ADDENDUM NO. 4

February 10, 2023

SOLON ROBINSON ELEMENTARY SCHOOL ADDITIONS, RENOVATIONS, AND RELATED WORK Crown Point, IN 46307

Thursday, 2/9/2023 — 11:56 AM — LAST SAVED BY:PDEGR Y:\21—109 CROWN POINT CSC — ROBINSON ES IMPROVEMENTS\21—109 DRAWINGS\05 ARCH\A—210.DWG

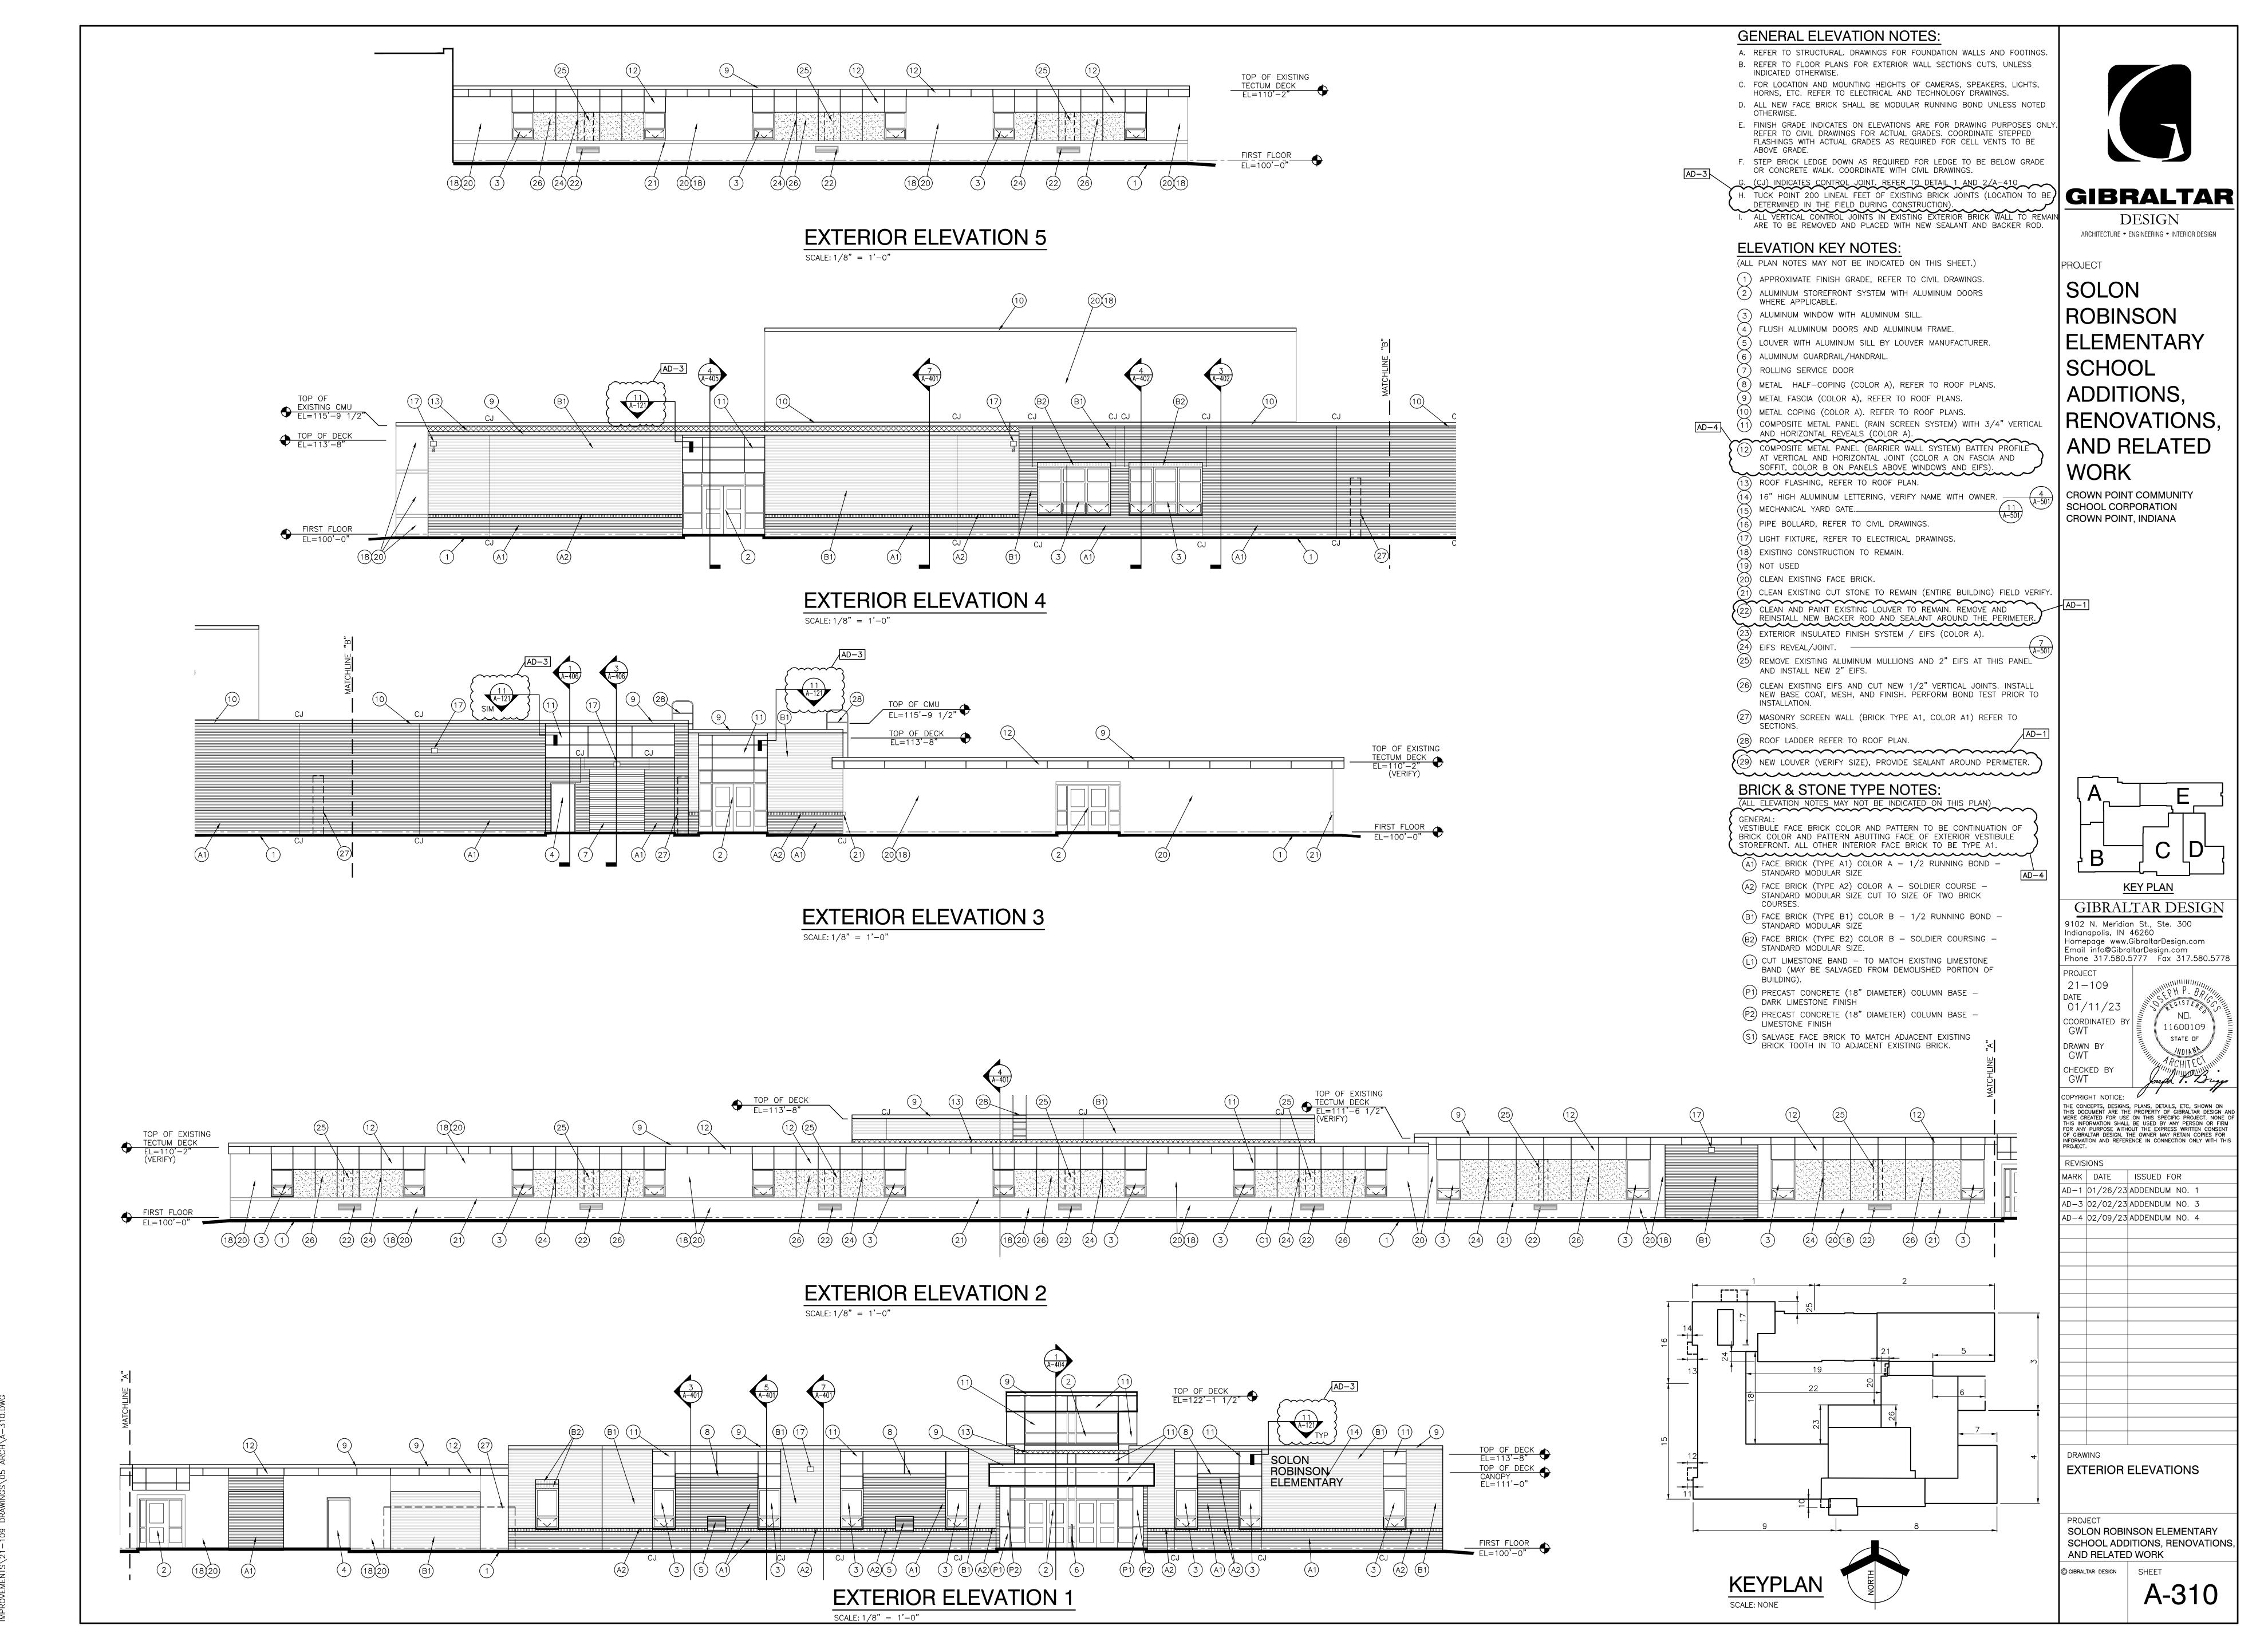
12. Sheet A-210

A. Roof Detail 13: Add note regarding metal panel color.

Thursday, 2/9/2023 — 11:58 AM — LAST SAVED BY:PDEGROTH Y:\21—109 CROWN POINT CSC — ROBINSON ES IMPROVEMENTS\21—109 DRAWINGS\05 ARCH\A—407.DWG

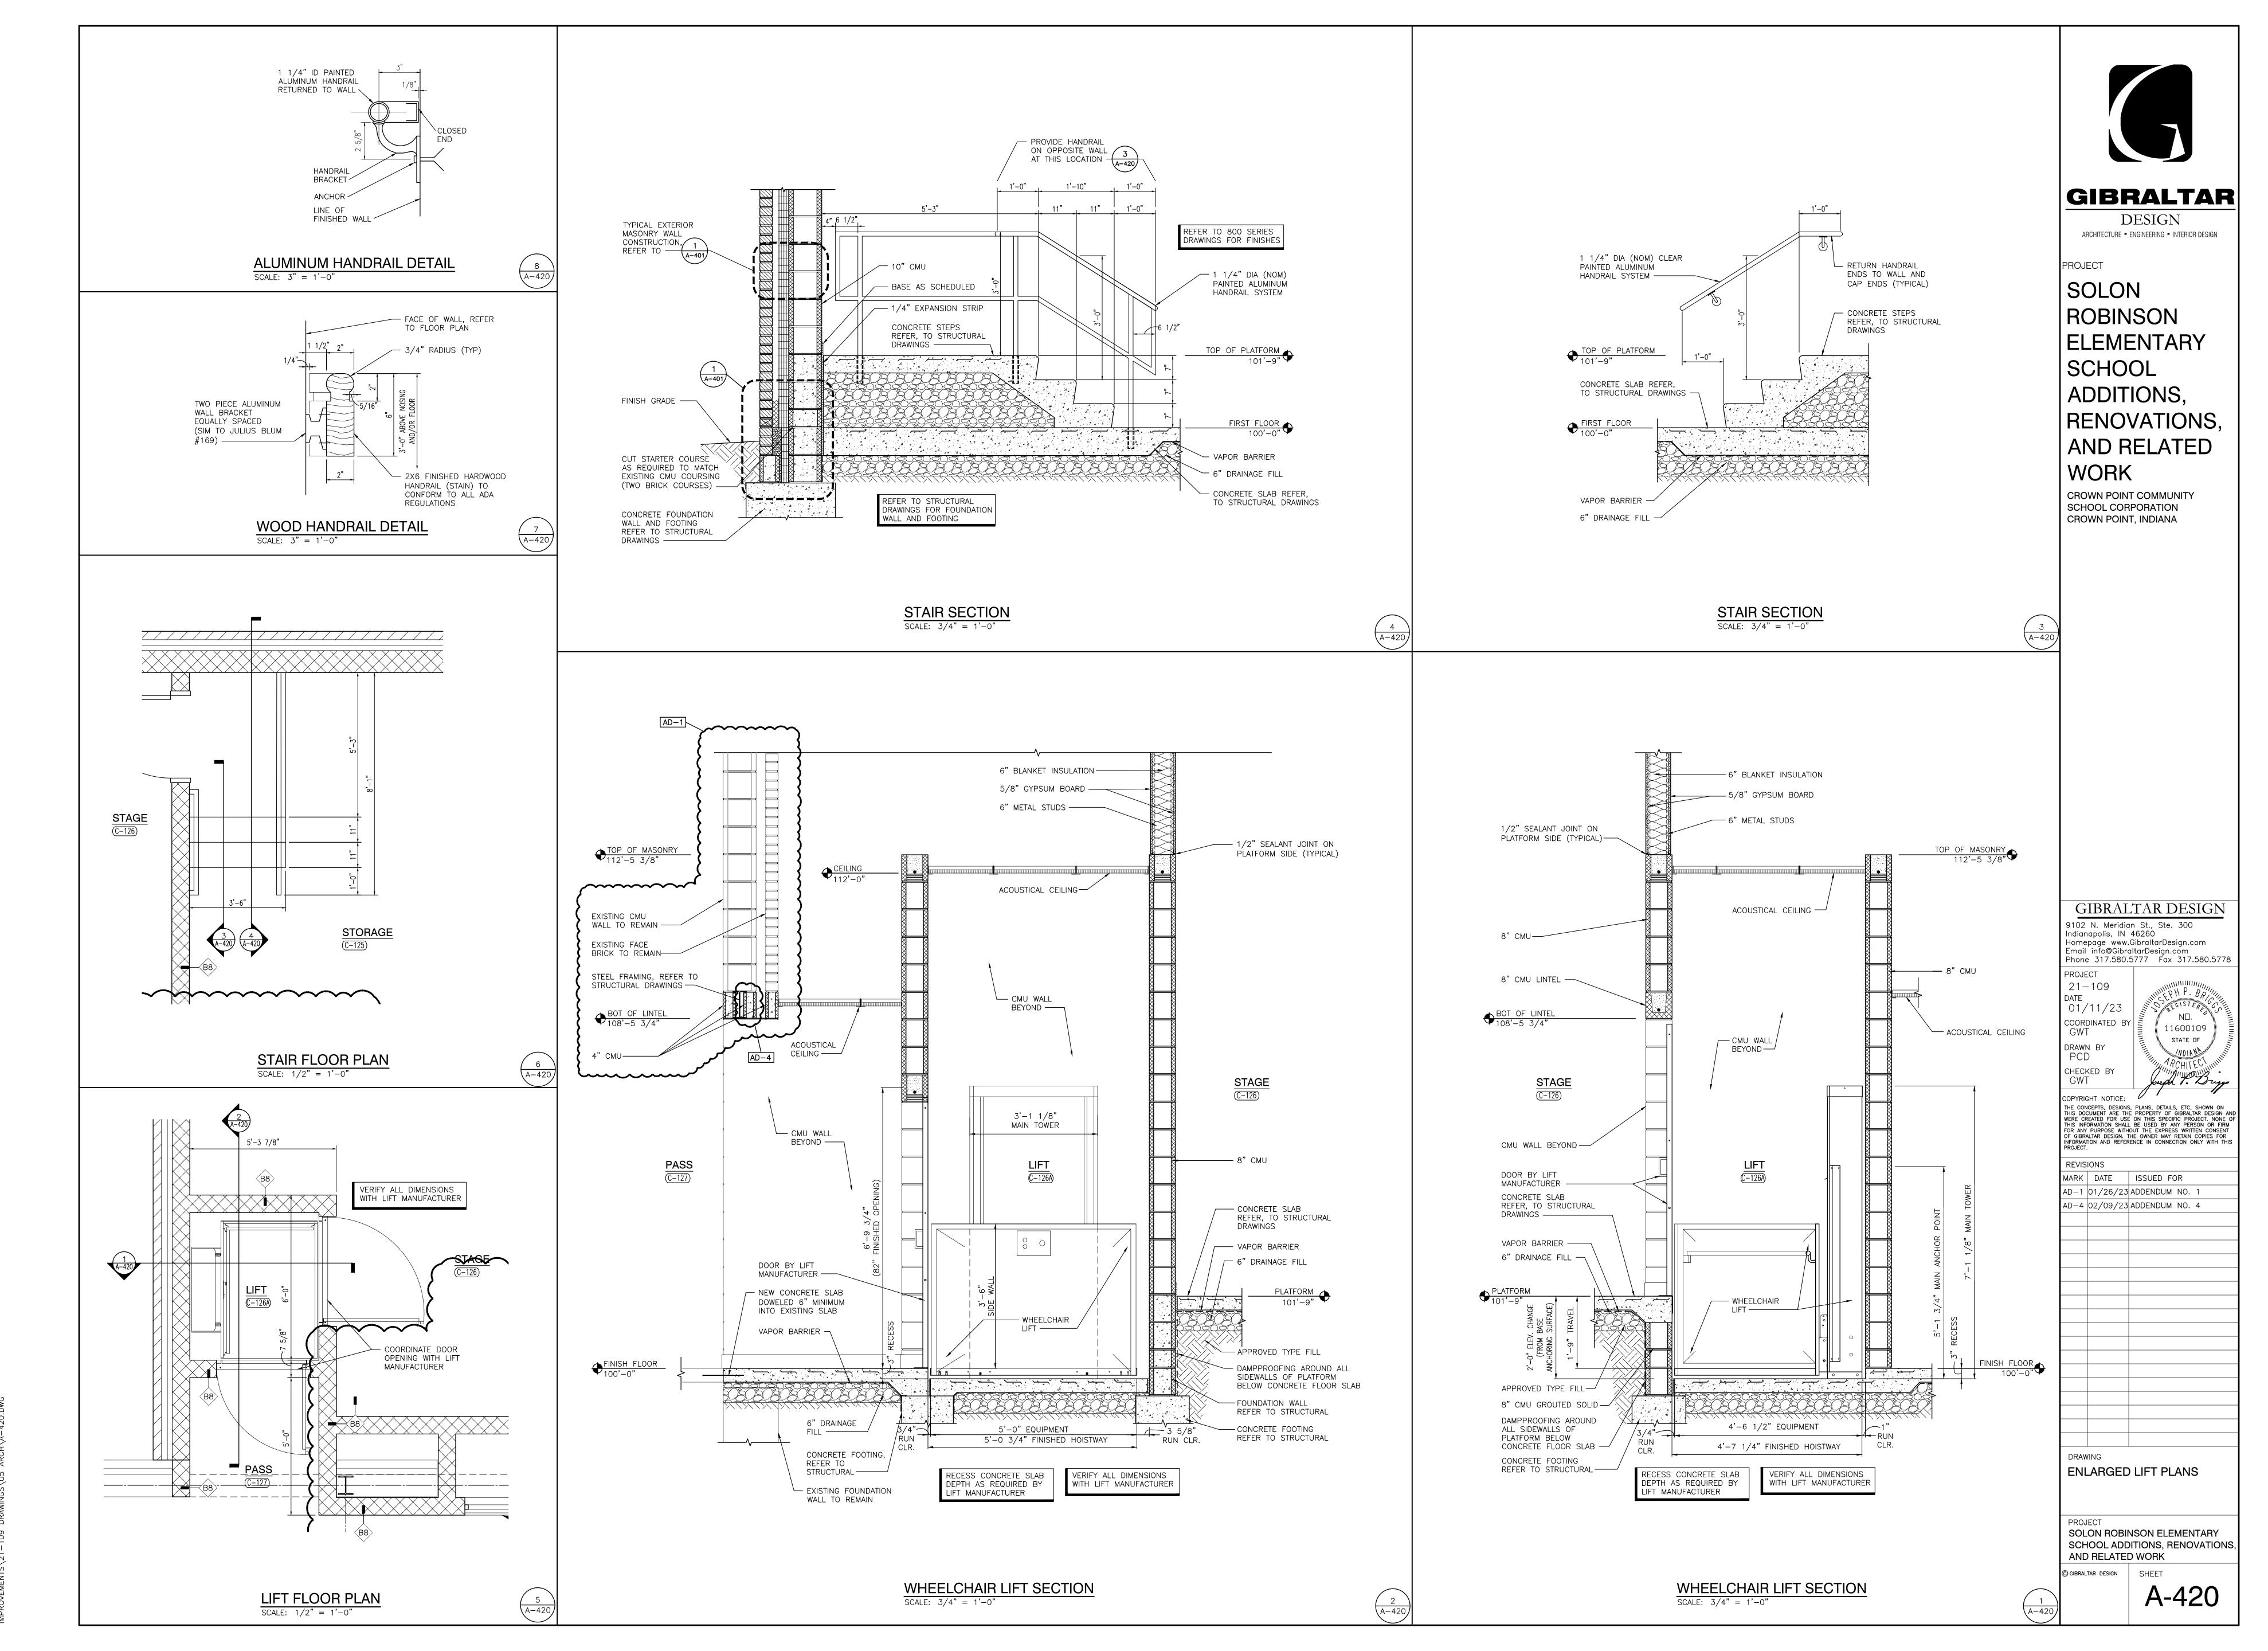
15. Sheet A-407

A. Wall Section 3: Add gypsum board and acoustical insulation.
